Comments on Document ACV5-7 Rev 1

The BLUE text are comments and proposed amendments from Colin Ross of Meritor:

TECHNICAL REQUIREMENTS FOR THE BRAKE ELECTRIC/ELECTRONIC INTERFACE
REQUIREMENTS FOR AUTOMATIC OR AUTOMATED ELECTRIC/ELECTRONIC BRAKE
CONNECTORS

I. FULLY ACV EQUIPPED

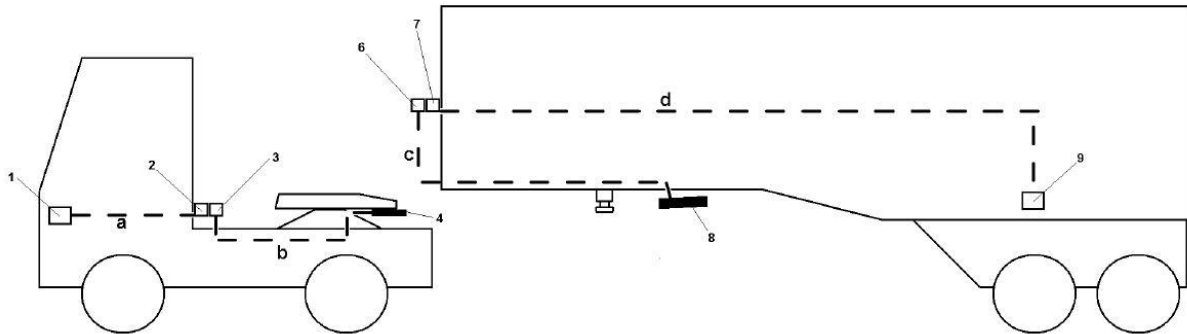
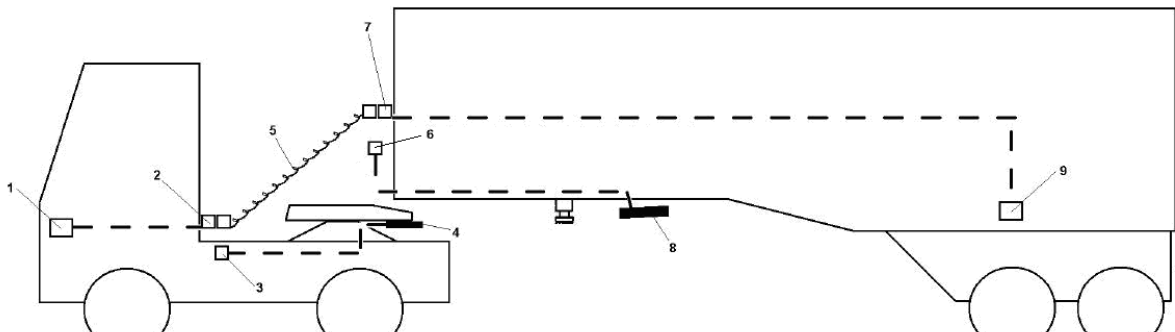
Comment: The diagram below only illustrates vehicles which are equipped with both automatic and manual connections. A new diagram should be added which defines automatic connection only.
